# HISTORIC AND DESIGN REVIEW COMMISSION

**HDRC CASE NO:** 2022-056  
**ADDRESS:** 555 S ALAMO ST  
**LEGAL DESCRIPTION:** NCB 901 BLK LOT 44, 45 & 46  
**ZONING:** D, H, RIO-3  
**CITY COUNCIL DIST.:** 1  
**DISTRICT:** La Villita Historic District  
**APPLICANT:** James McKnight/Brown & Ortiz, PC  
**OWNER:** Eric Stone/AUTO HOTEL LLC  
**TYPE OF WORK:** Construction of a fitness center, construction of accessory structures, site modifications,  
**APPLICATION RECEIVED:** January 14, 2022  
**60-DAY REVIEW:** Not applicable due to City Council Emergency Orders  
**CASE MANAGER:** Edward Hall

**Historic and Design Review Commission**  
***Design Review Committee Report***

06 EVENT CANOPY - OVERALL CANOPY SECTION  
3/16" = 1'-0"

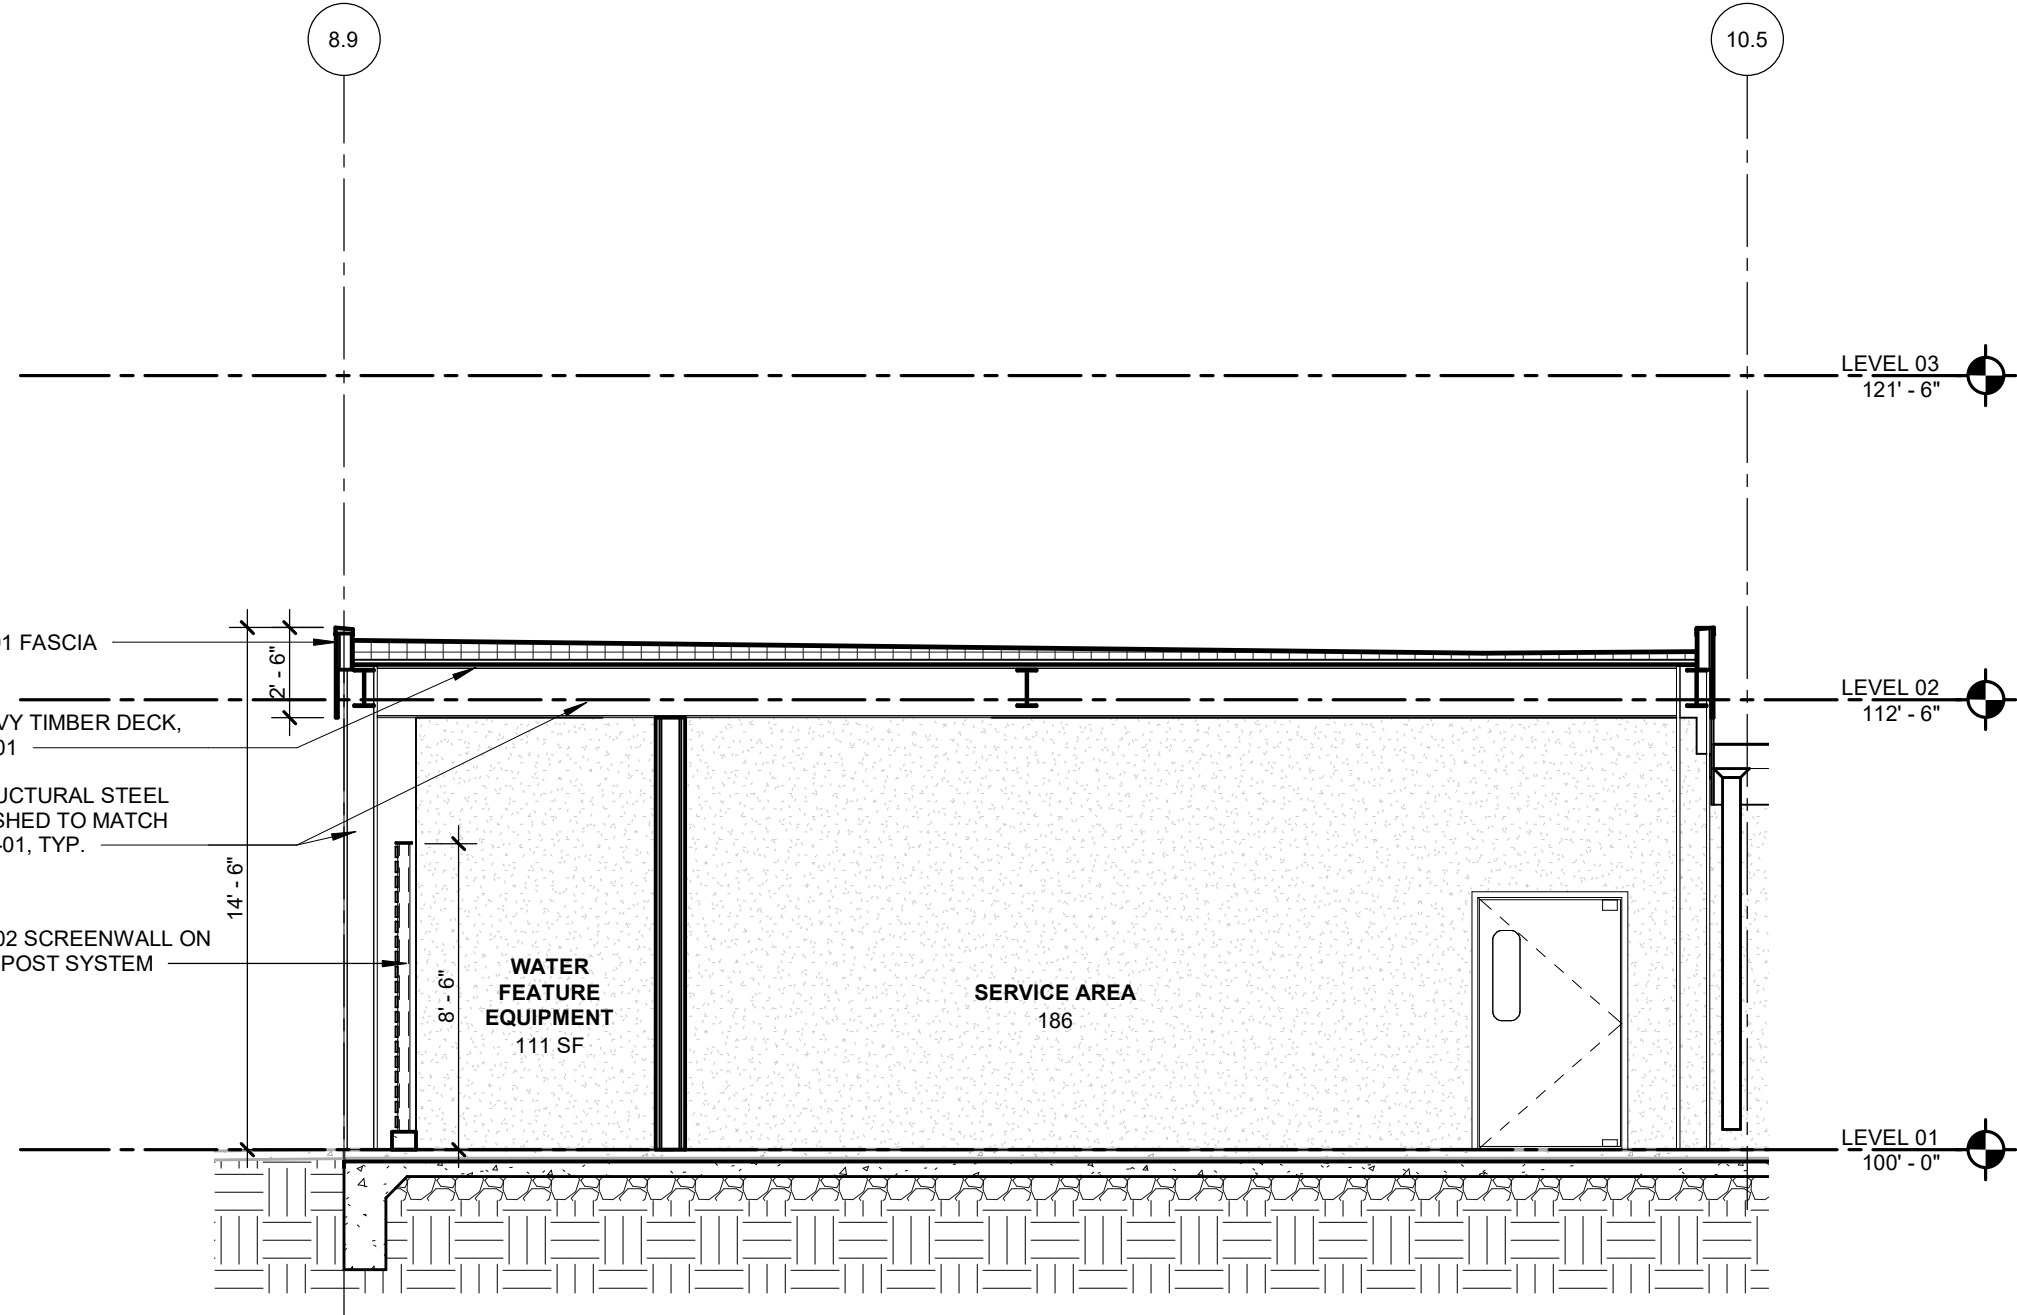
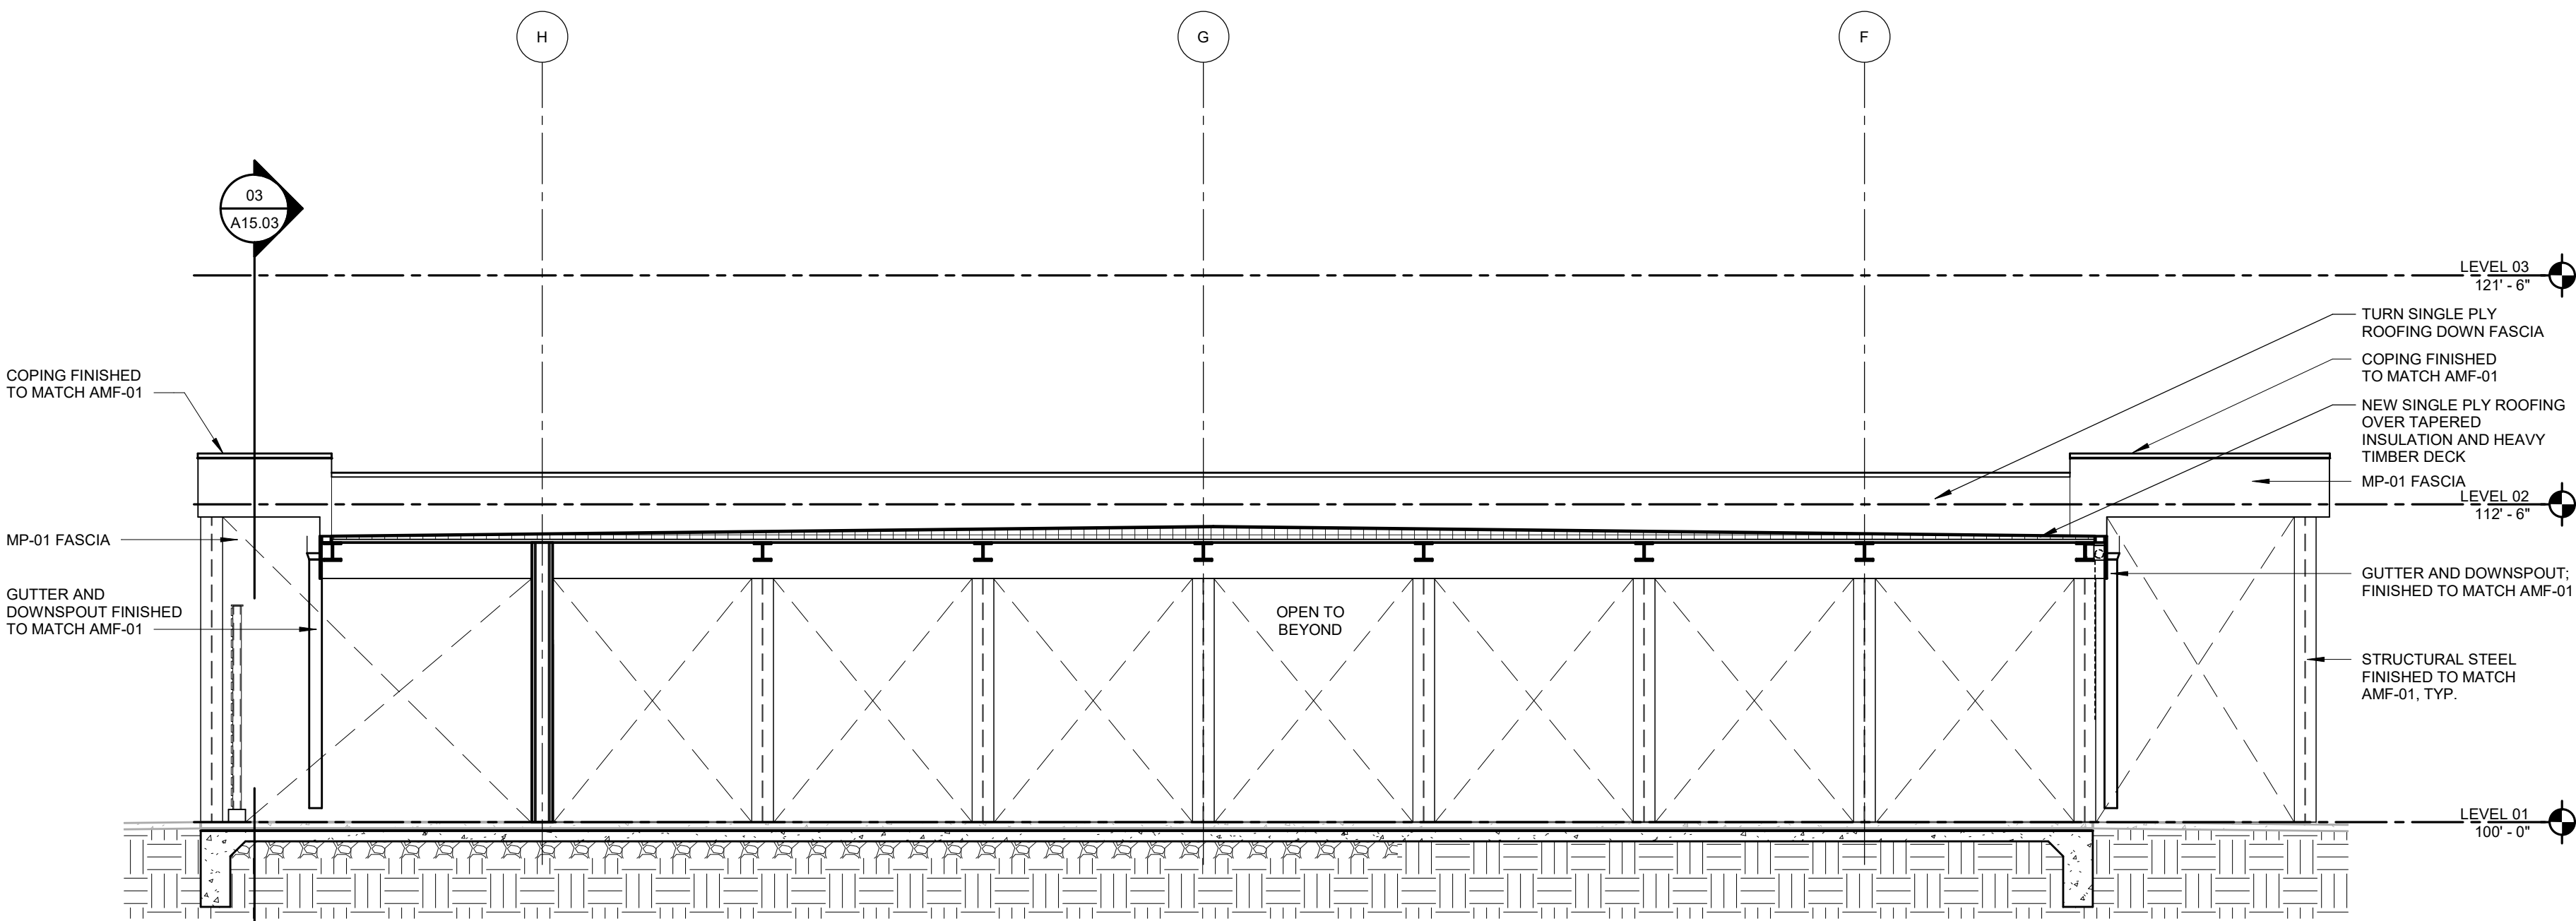
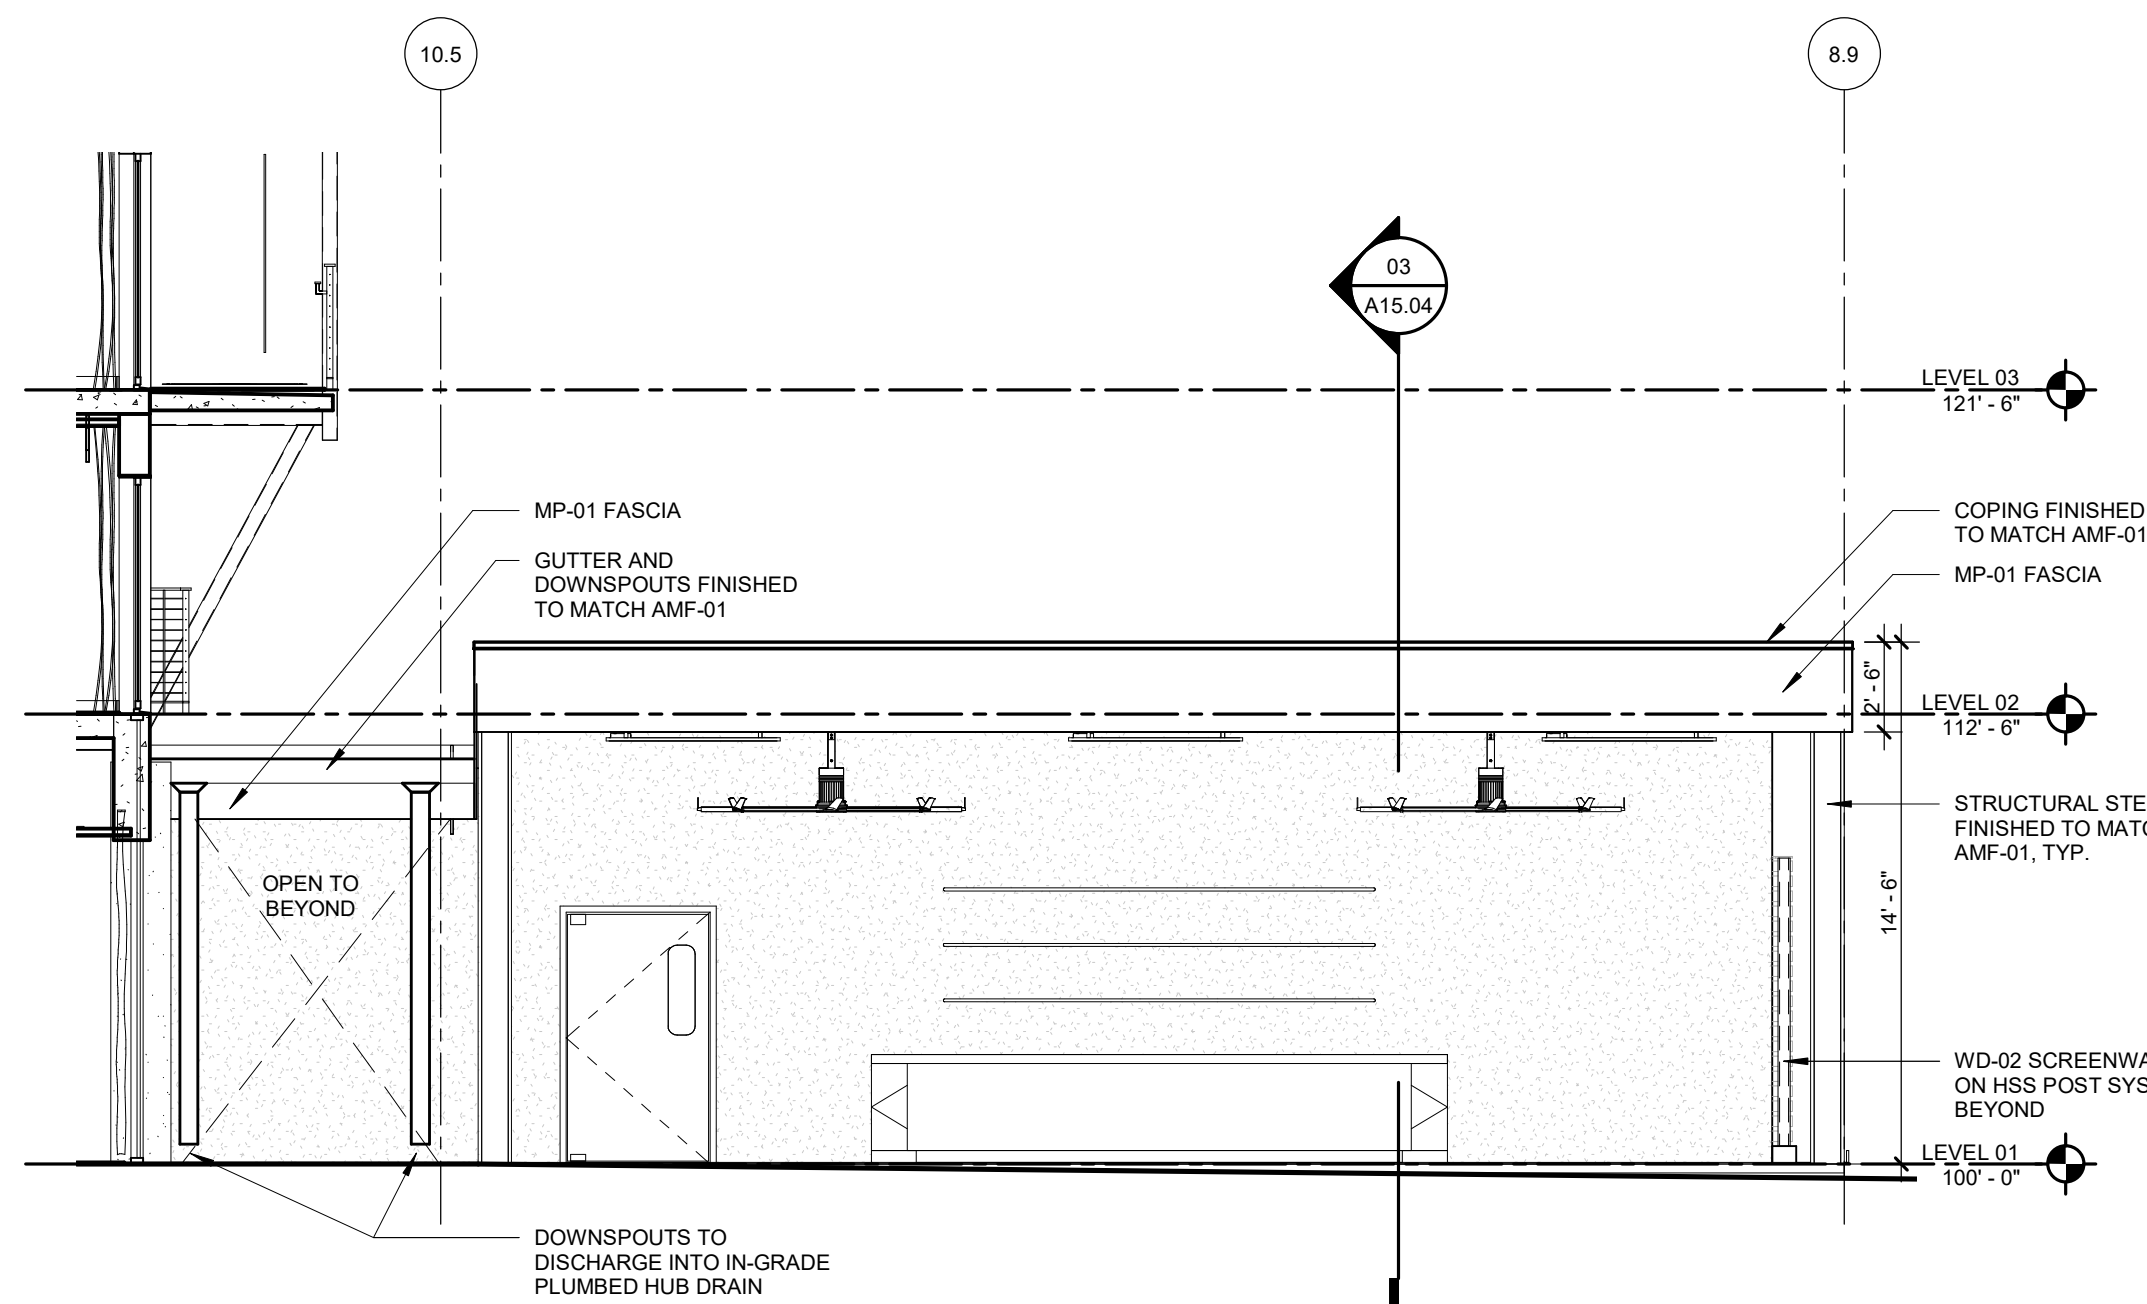
- d. **EVENT STRUCTURE** – The applicant has proposed to construct an open-air, steel structure over the existing lawn area. This is a modification to the previously approved structure at this location. The structure will feature a painted steel structure with wood soffits and a concrete floor. The proposed structure will cover an area of approximately 3,200 square feet and feature an overall height of thirteen (13) feet in height. Staff finds the proposed new construction, its design and location to be appropriate.

ZJ: Overview of updates to the event center structure (Change in design).

- 1. Staff recommends approval of item #1, the construction of an event structure as submitted based on finding d.
- 2. Staff recommends approval of item #2, the construction of a pool structure as submitted based on finding e.
- 3. Staff recommends approval of item #3, the construction of a fitness structure based on findings f through j with the following stipulation:
  - i. That the proposed composite siding feature a smooth finish and an exposure of four (4) inches.
